**Re: Heritage Market Place
1820 Unser Blvd., NW
Request for Temporary Certificate of Occupancy- Transportation
Development
Engineer's/Architect's Stamp dated 4-9-15 (H09-D024)
Certification dated 1-04-15/6**

**RE: SITE PLAN FOR BUILDING PERMIT CERTIFICATION
CERTIFICATION FOR TEMPORARY CERTIFICATE OF OCCUPANCY
HERITAGE MARKET WALMART, 1820 UNSER BLVD NW**

ENGINEER'S SEAL	HERITAGE MARKET PLACE ALBUQUERQUE, NM	DRAWN BY pm
	PAD D SITE PLAN FOR BUILDING PERMIT	DATE 2-17-15
RONALD R. BOHANNAN P.E. #7868	TERRA WEST, LLC 5571 MIDWAY PARK PL NE ALBUQUERQUE, NEW MEXICO 87109 (505) 858-3100 www.tierrawestllc.com	DRAWING 2014038-SPC
		SHEET NO SP-1
		JOB # 2014038

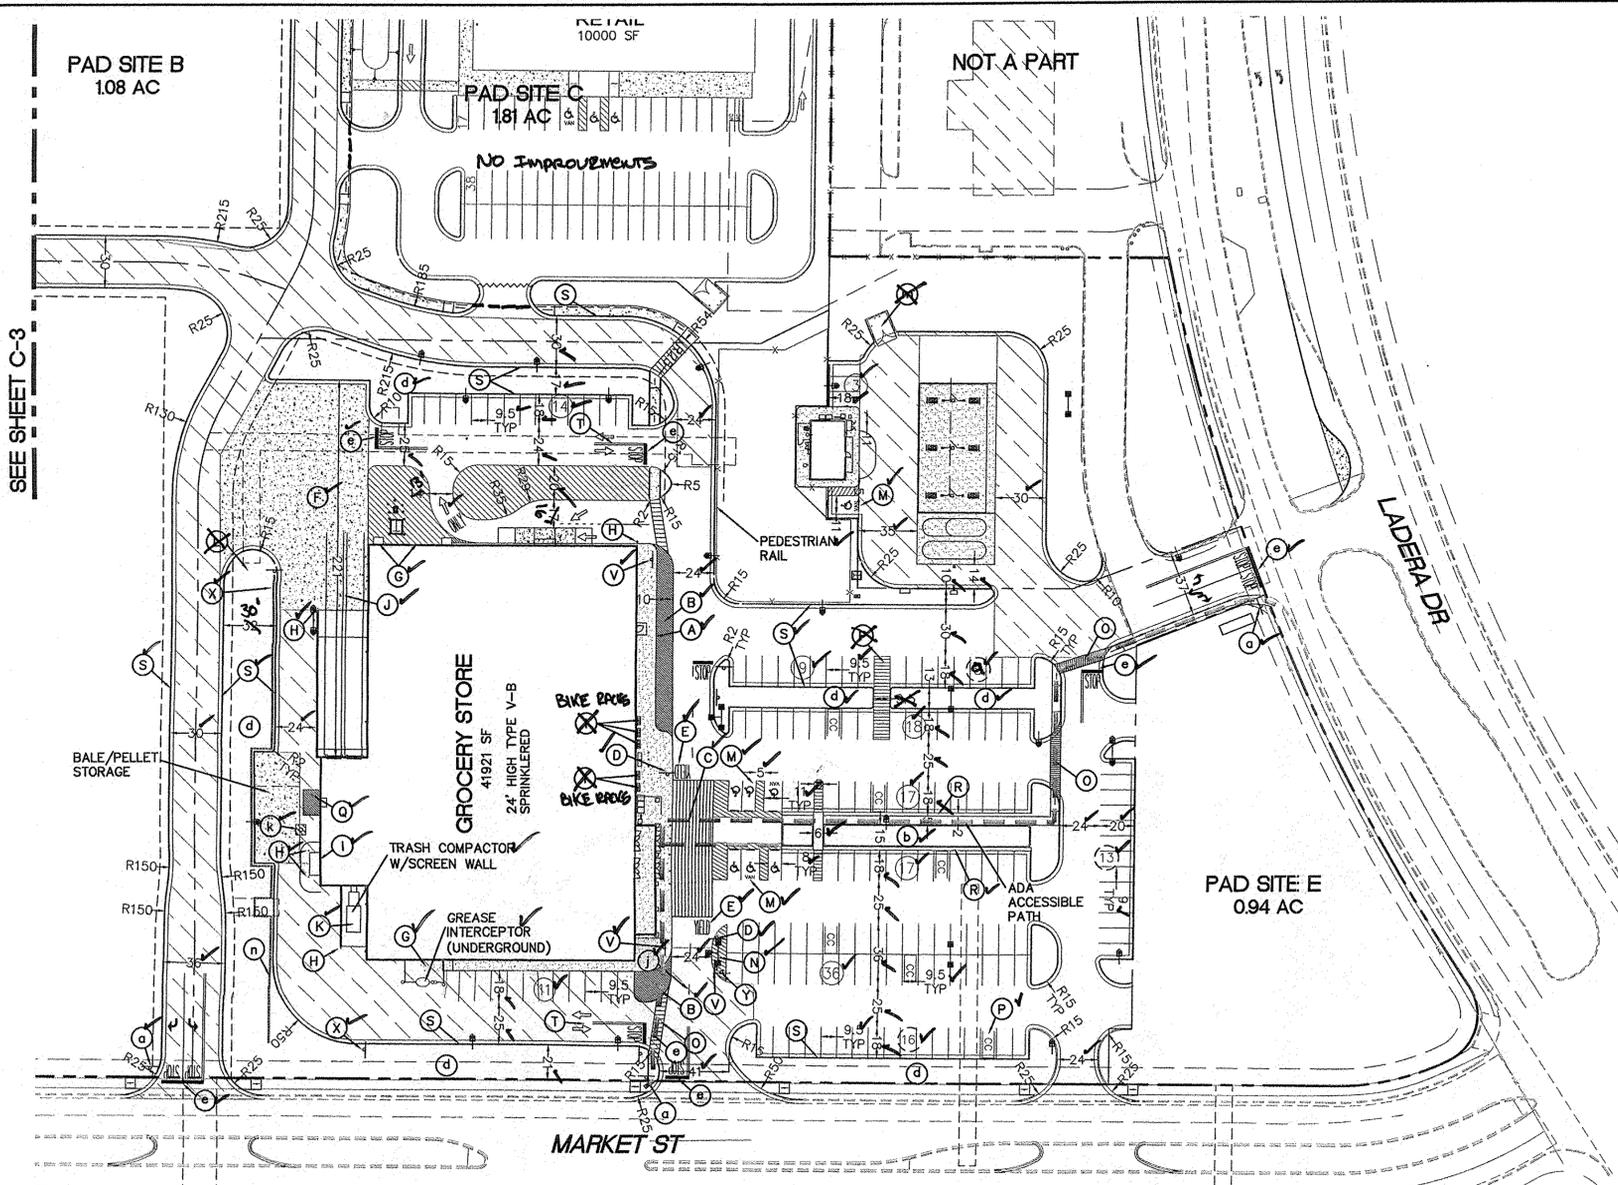
1. Add Stop signs at interior 4-Way intersection south west of the building.
2. Truncated domes along all public Right of Ways need to be installed.
3. ADA parking spaces do not meet number of required spaces. ADA pavement between ADA parking spaces needs to be marked with cross hatching.
4. Motorcycle parking is missing and required.
5. Additional signage and striping is required to prevent left hand turns at the shopping center exit located approximately 500 ft. south of Ladera Blvd. on Market Street.
6. "No Trucks" sign Key Note "K" needs to be installed at the eastern entrance.
7. Painted "Yield" on pavement on the north side of store needs to be repainted, due to discoloration.
8. Work Order must be complete and accepted prior to final C.O.

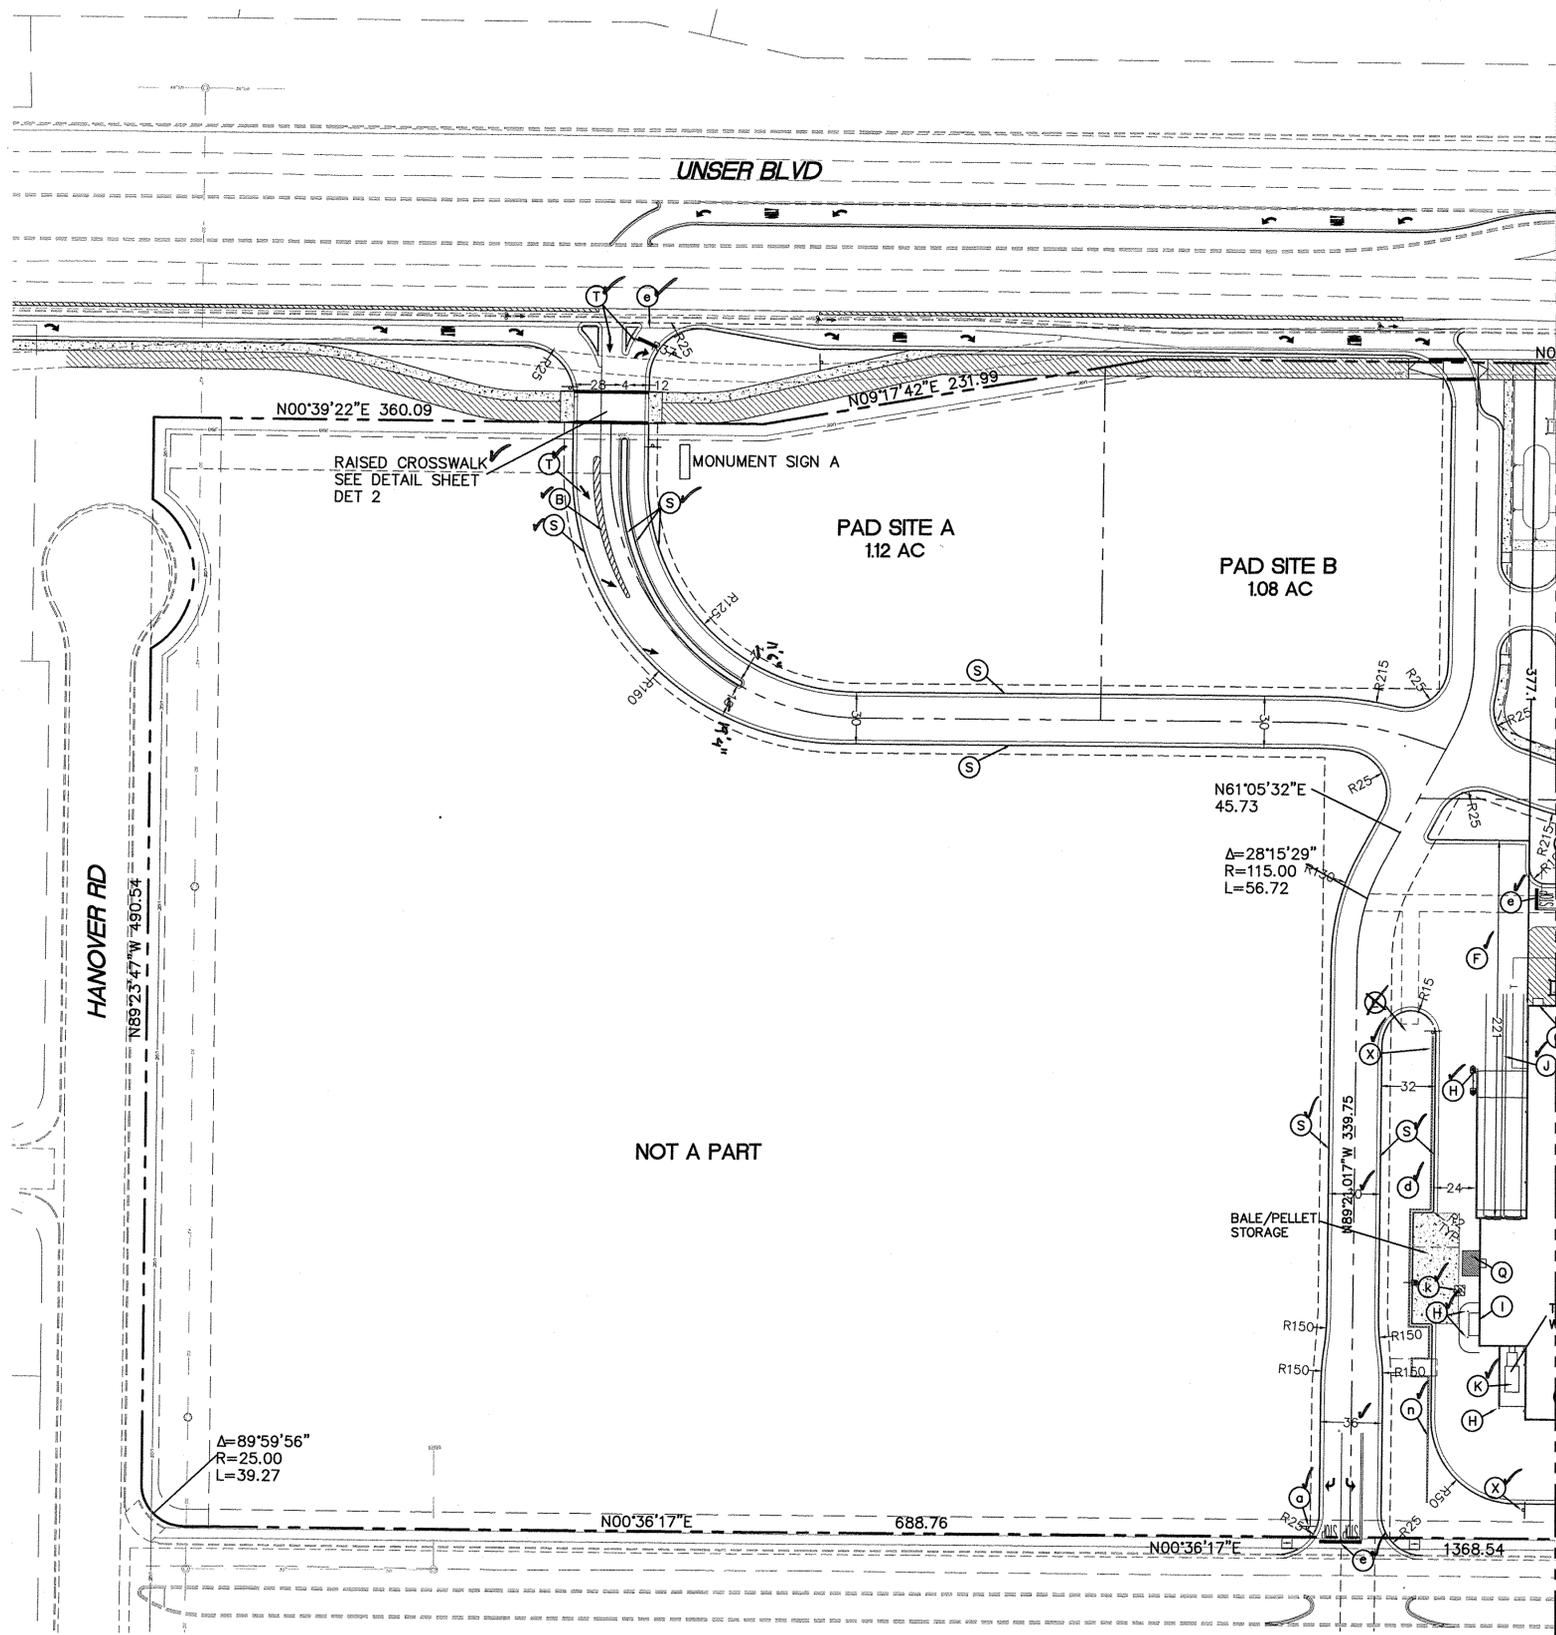
- ✓ (A) 6" WIDE FIRE LANE STRIPING PAINTED TRAFFIC RED W/ "NO PARKING FIRE LANE" PAINTED WITH 4" HIGH WHITE LETTERING AT 25' O.C. SEE DETAIL SHEET C-8 - *PER FIRE DEPARTMENT DIRECTIONS*

- ✓ (H) 6" DIA PIPE BOLLARD TYPICAL UNLESS NOTED OTHERWISE. SEE DETAIL SHEET C-8 *MISSING AT COMPACTOR R, NW BOLDING CORNER*
- ✓ (I) AT GRADE OVERHEAD DOOR LOCATION. SEE ARCHITECTURAL PLANS FOR EXACT SIZE AND LOCATION FOR COORDINATION WITH CIVIL PLANS.

- ✗ (X) CONCRETE TRANSFORMER PAD. CONTRACTOR TO COORDINATE WITH LOCAL POWER COMPANY FOR DETAILS. *MOVED TO SW CORNER OF BUILDING*
- ✓ (M) ACCESSIBLE PARKING SPACE TYPICAL. SEE DETAIL SHEET FOR ACCESSIBLE PARKING SPACE SIZE, SIGN AND SYMBOL ("VAN"-INDICATES VAN ACCESSIBLE SPACE). *LACKING ONE SPACE TO BE ADDED*

- ✓ (O) 8'-0" WIDE PEDESTRIAN CROSSWALK. SEE DETAIL SHEET C-8
- ✓ (P) CART CORRAL TYPICAL. SEE DETAIL SHEET C-9 - *Temp locations*
- ✓ (Q) 10' X 15' STRIPED AREA PAINTED SYSL/4" AT 45' @ 2'-0" O.C. AT JIB CRANE LOCATION. SEE ARCH. PLANS.

- ✓ (T) ARROW PAVEMENT MARKINGS TYPICAL. SEE DETAIL SHEET C-8
- ✓ (U) BUILDING SETBACK LINE PER ZONING ORDINANCE.
- ✓ (V) "NO PARKING FIRE LANE" SIGN. SEE PLAN FOR LOCATION. *MISSING SIGN AT ENTRANCE AT MARKET ST.*

- ✗ (3) 3' HD CONCRETE BUFFER FOR LANDSCAPE PROTECTION. SEE DETAIL SHEET C-8 *NOT USED*
- ✗ (D) "DELIVERY TRAFFIC ONLY" SIGN. SEE DETAIL SHEET C-10 *NOT USED*

- ✓ (Y) "NO TRUCKS" SIGN. SEE DETAIL SHEET C-10 *MISSING SIGN AT ENTRANCE AT MARKET ST.*
- ✓ (Z) "TRUCK ROUTE" SIGN. SEE PLAN FOR LOCATION.
- ✓ (a) "STOP" SIGN. SEE DETAIL SHEET C-9

- ✗ (h) ADVANCED INTERSECTION LANE CONTROL SIGN. SEE DIRECTION INDICATED AT SYMBOL. SEE DETAIL SHEET.
- ✓ (i) ACCESSIBLE "SITE ARRIVAL POINT". SEE PLAN FOR LOCATION AND LIMITS. *- ROUTE TO BE CERTIFIED*
